17 December, 1999  
LD-1999-0062

**SUBJECT: RESPONSE TO NRC REQUEST FOR ADDITIONAL INFORMATION  
SUPPORTING TOPICAL REPORT CENPD-397-P REVIEW ACTIVITIES**  
~~(ENCLOSURE 1 CONTAINS PROPRIETARY INFORMATION)~~

## NON-PROPRIETARY RESPONSE TO NRC REQUEST FOR ADDITIONAL INFORMATION SUPPORTING TOPICAL REPORT CENPD-397-P REVIEW ACTIVITIES

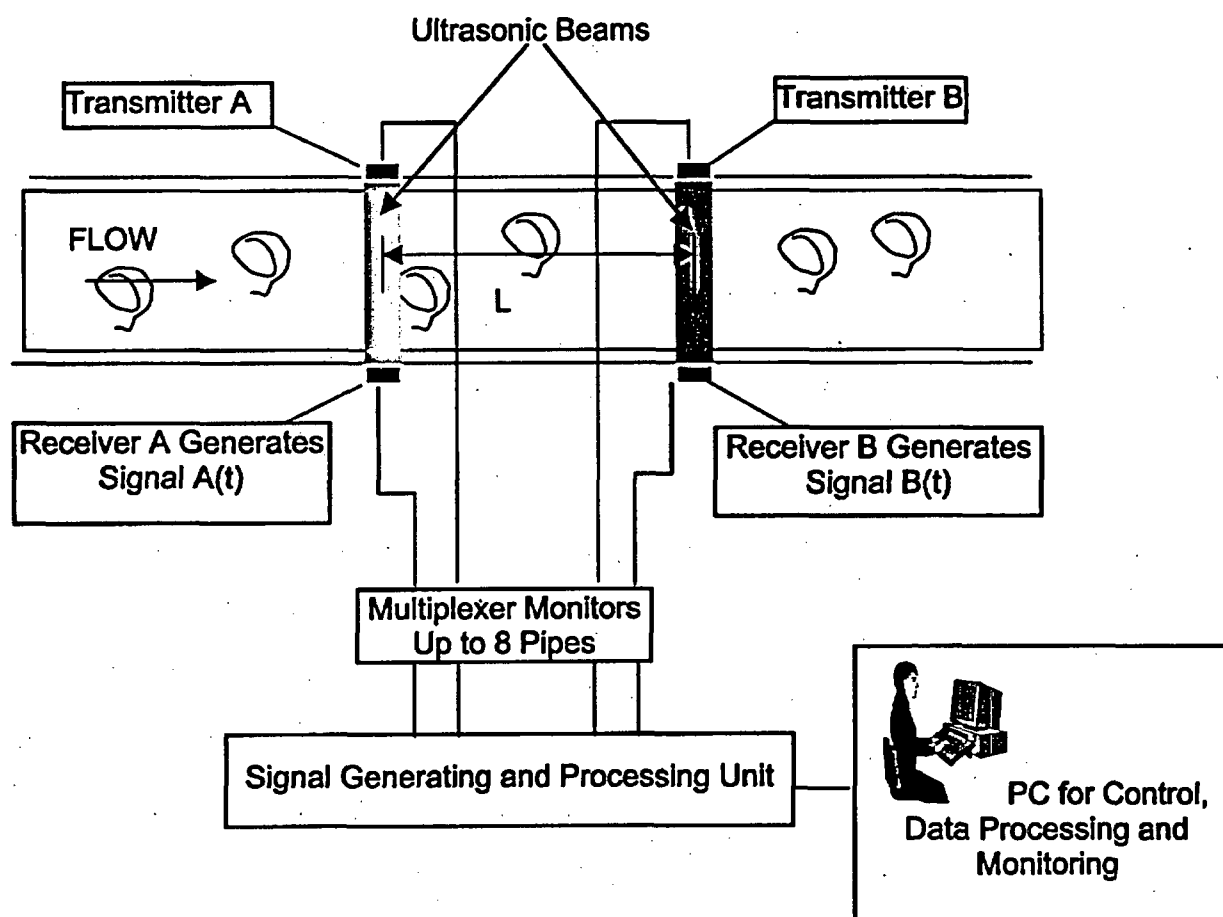
Section 2.2.2 defined cross-correlation as a "mathematical process for determining the displacement in time between similar curves." Please explain equations 2-9 and 2-10 and graphically identify the similar curves. Are the two signals  $A(t)$  and  $B(t + \tau)$  through two different eddies or through the same eddy traveling between station A and station B?

It should be noted that the equations in Section 2.2.2 have been renumbered due to revisions in Section 2.1 of the topical report, CENPD-397-P, Rev. 00. Equation 2-9 is now Equation 2-5 and Equation 2-10 is now Equation 2-6.

The underlying principle of the cross-correlation technique is illustrated in the following figure:
